HISTORIC AND DESIGN REVIEW COMMISSION

May 19, 2021

HDRC CASE NO: 2020-557
COMMON NAME: 918 N OLIVE
ADDRESS: 914 N OLIVE ST
LEGAL DESCRIPTION: NCB 531 BLK 13 LOT W 150 FT OF 4
ZONING: IDZ, H
CITY COUNCIL DIST.: 2
DISTRICT: Dignowity Hill Historic District
APPLICANT: Ricardo Turrubiates /K/T TX HOLDINGS LLC
OWNER: K/T TX HOLDINGS LLC
TYPE OF WORK: Construction of nine, 2-story residential structures, construction of carports
APPLICATION RECEIVED: April 16, 2021
60-DAY REVIEW: Not applicable due to City Council Emergency Orders
CASE MANAGER: Edward Hall

The applicant is requesting a Certificate of Appropriateness for approval to construct nine, 2-story residential structures on the vacant lots addressed as 914 and 918 N Olive, located within the Dignowity Hill Historic District.

Olive Court

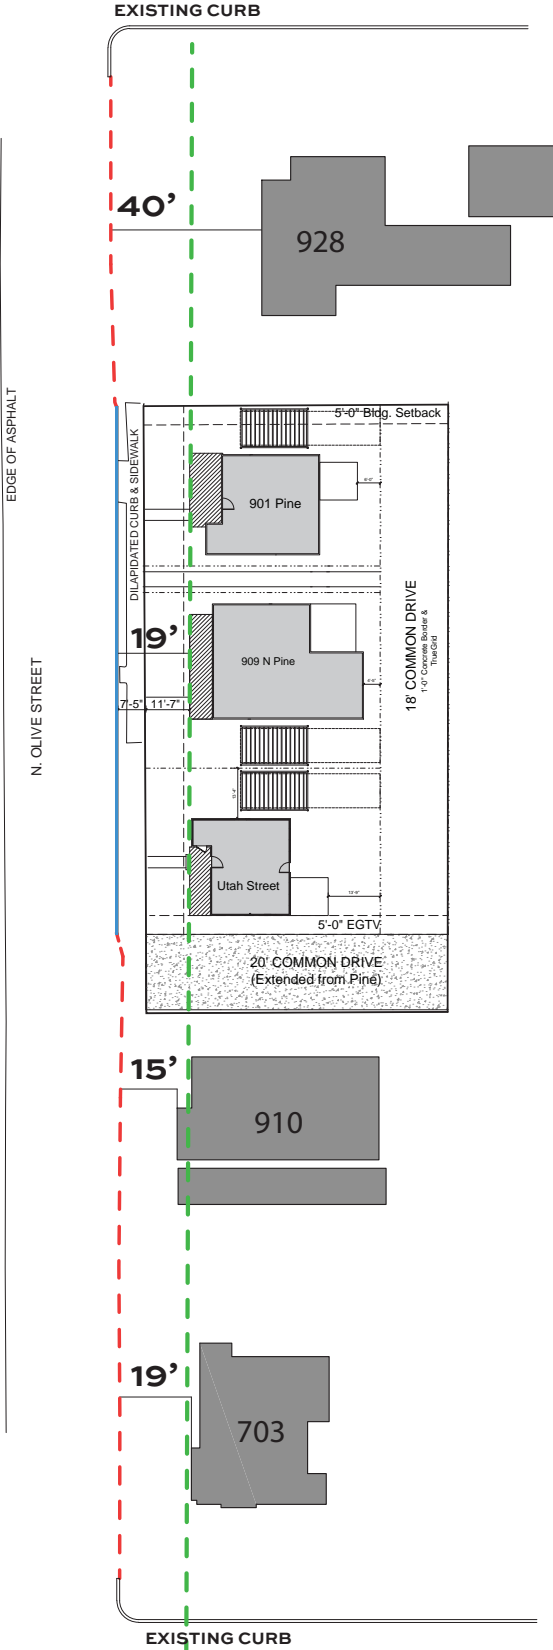
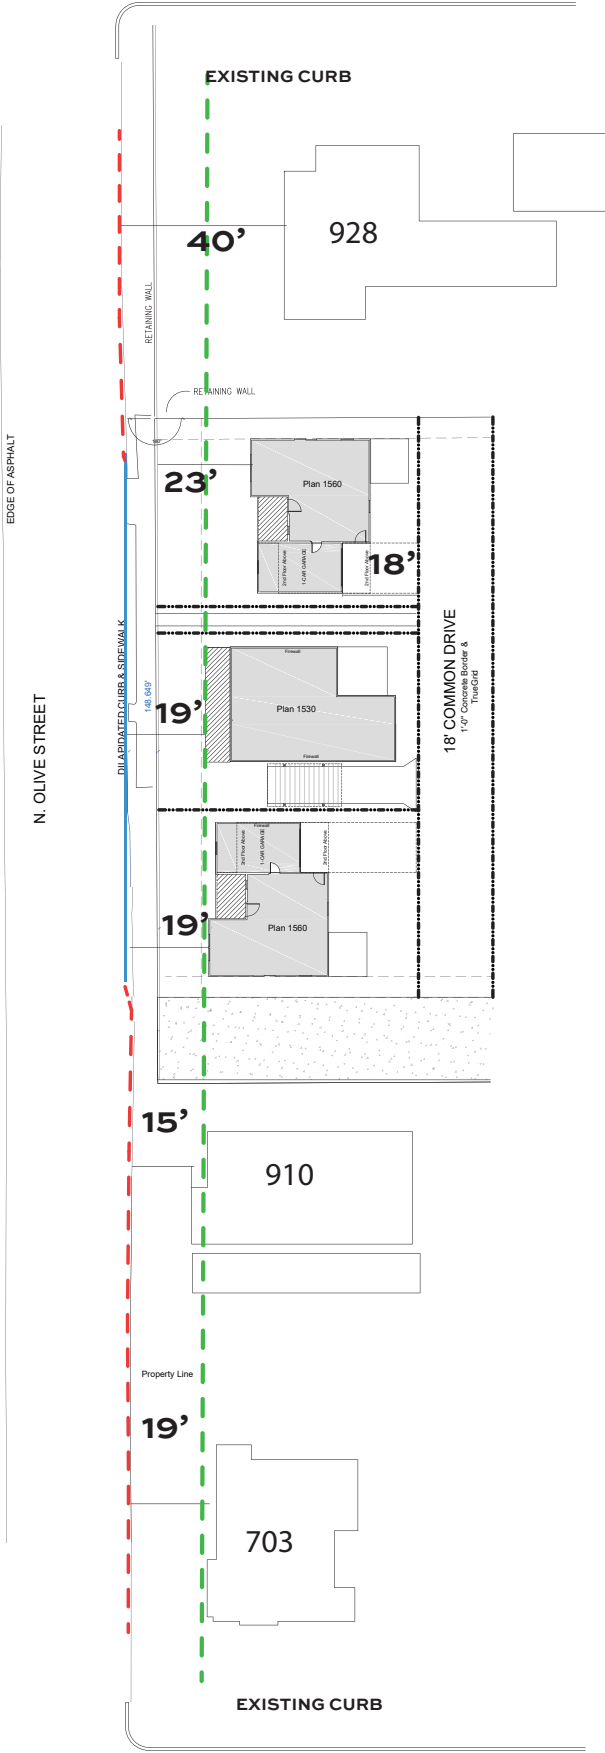
JF: Have steps been considered to increase the setback of the 901 Plan to create a stepped setback to further relate to 928 N Olive?

JF: Show why proposed setback of 23 feet is the greatest possible for the northern most structure.

*REQUESTING NEW SET BACK TO BE 19' FROM CURB - RULING OUT THE HIGH OF 40' AND THE LOW OF 15' MATCHING THE MEDIAN OF 19'

*REQUESTING NEW SET BACK TO BE 19' FROM CURB - RULING OUT THE HIGH OF 40' AND THE LOW OF 15' MATCHING THE MEDIAN OF 19'

MKT ELEVATION
1/4" = 1'-0"

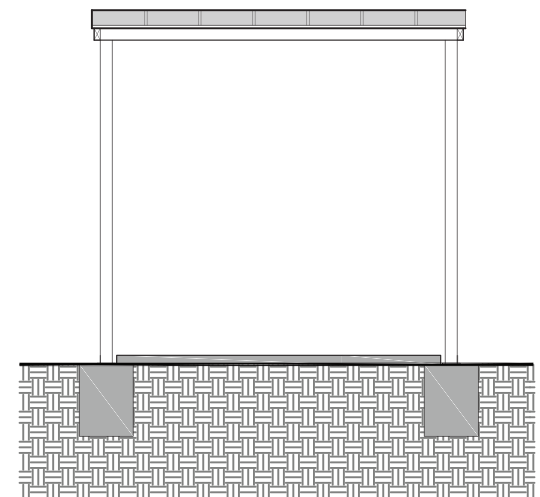
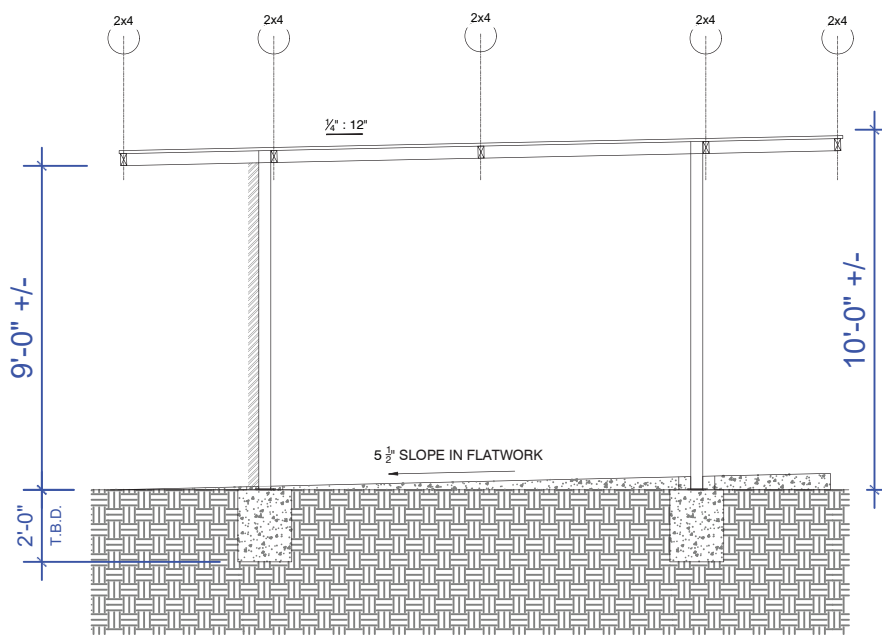
- i. That proposed standing seam metal roof should feature panels that are 18 to 21 inches wide, seams that are 1 to 2 inches in height and a standard galvalume finish. A crimped ridge seam is to be used and if a ridge cap is requested, it must feature a low profile and be approved by staff prior to installation.

Agreed to Do

FLOOR PLAN - LEVEL 1
SCALE: 1/4" = 1'-0"

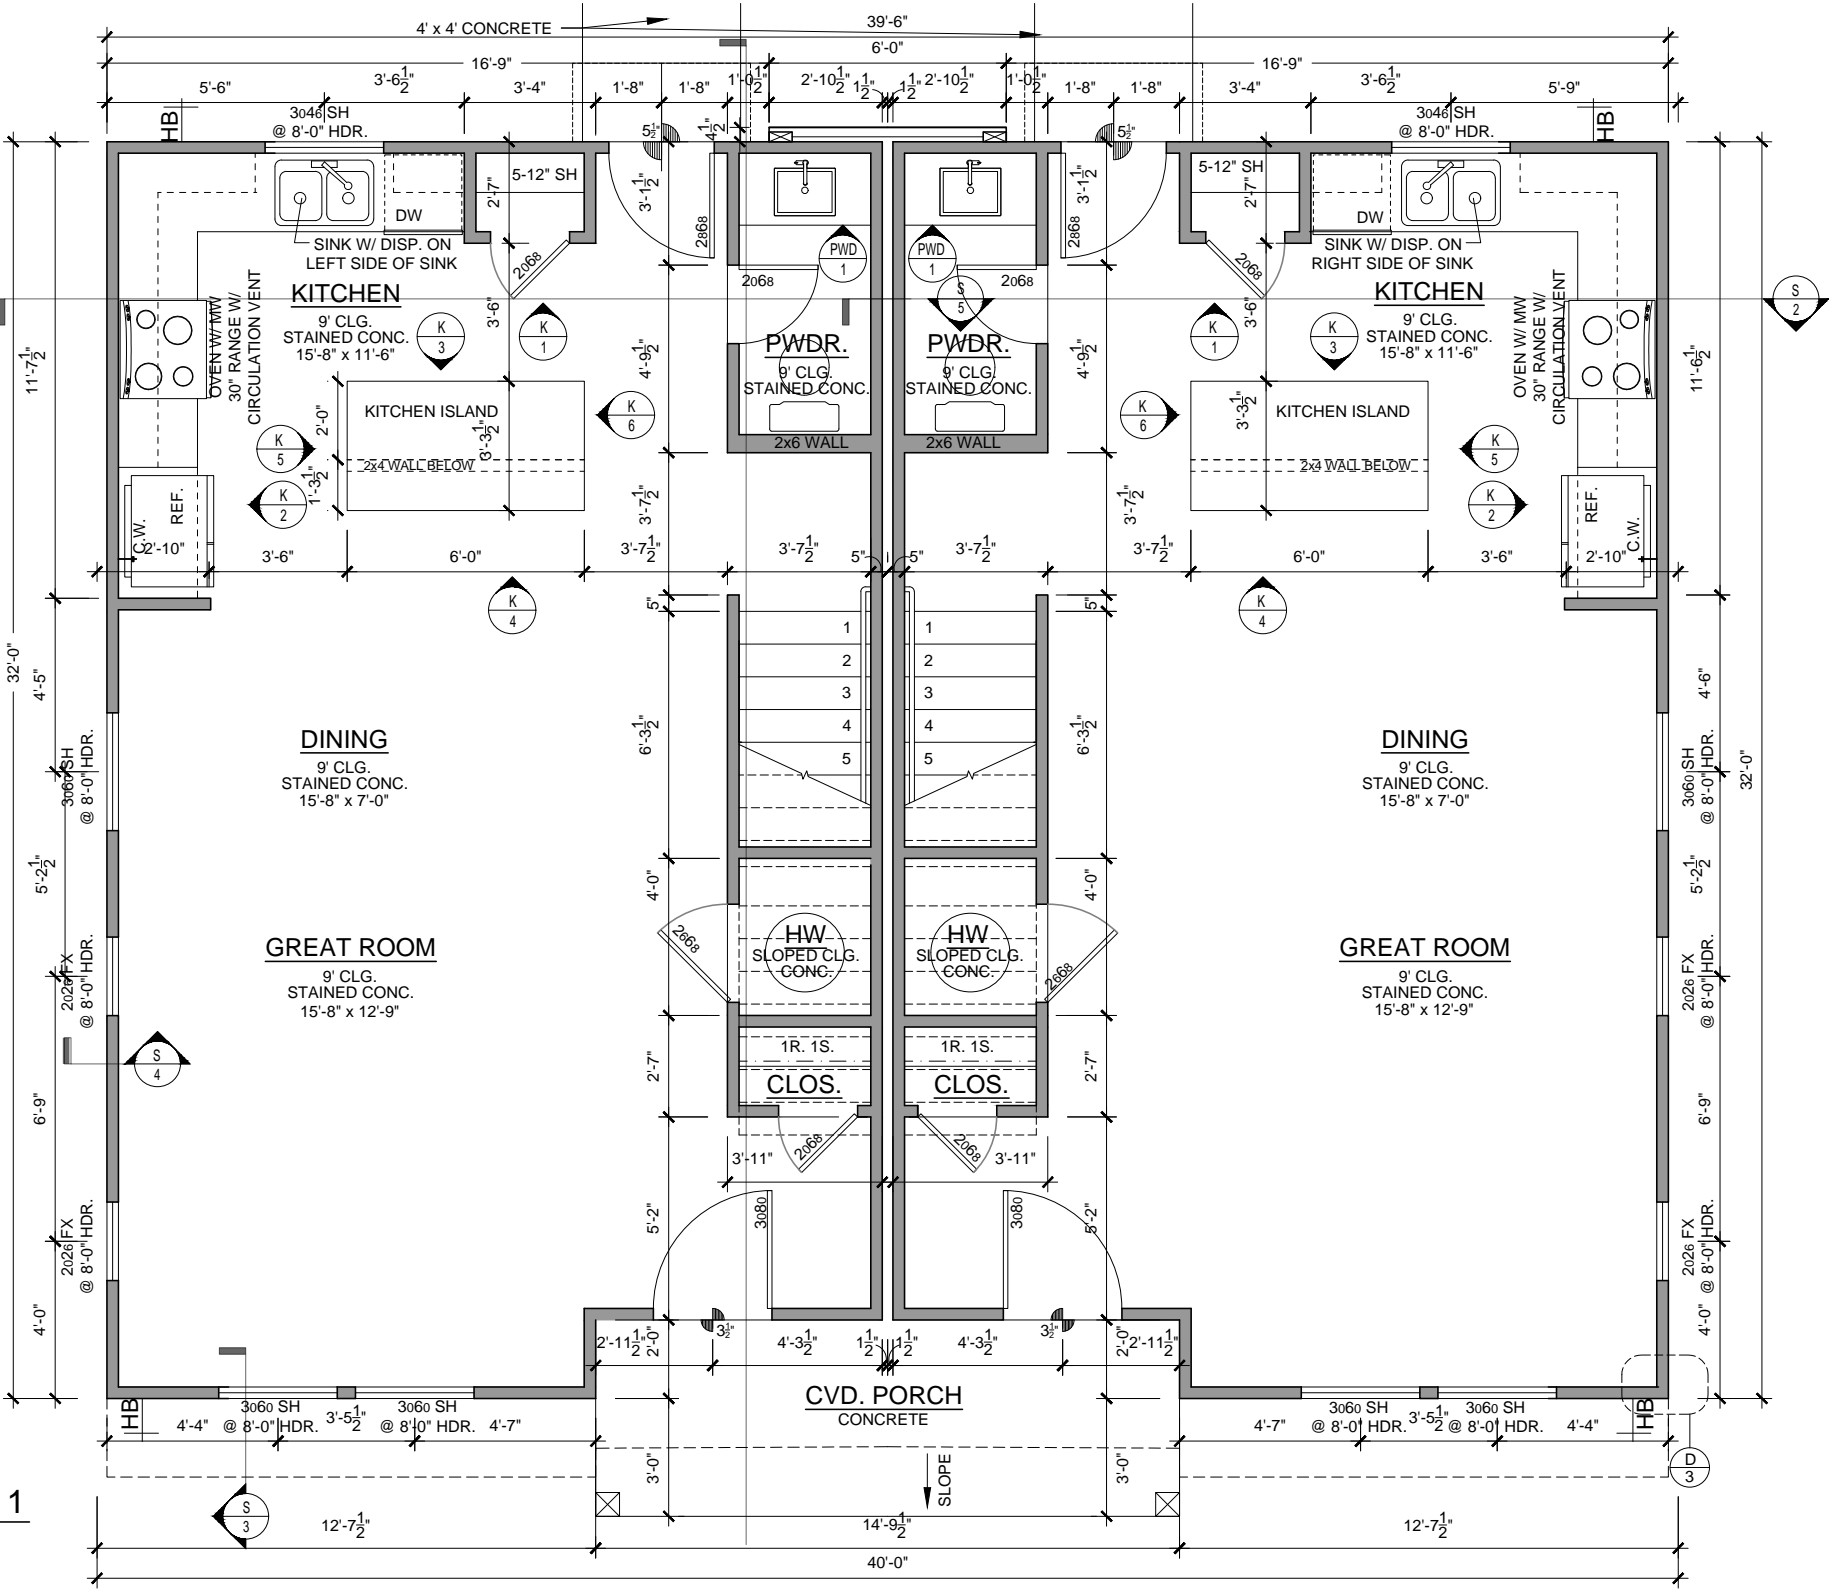
- vi. That the applicant add additional and appropriately sized fenestration to elevations including but not limited to the right elevation of plan 1560 (including plan B), the right and left elevations of plan 1218, the right and left elevations of plan 1525, and the left and right elevations of plan 1233. Staff recommends that full size windows should be added to both the right and left elevations of plan 1530.

WILL NOT BE ABLE TO INCREASE FENESTRATION DUE TO THE IRC BUILDING CODE - WITH THIS WALL BEING A FIREWALL WE ARE NOT ALLOWED TO EXCEED 25% FENESTRATION
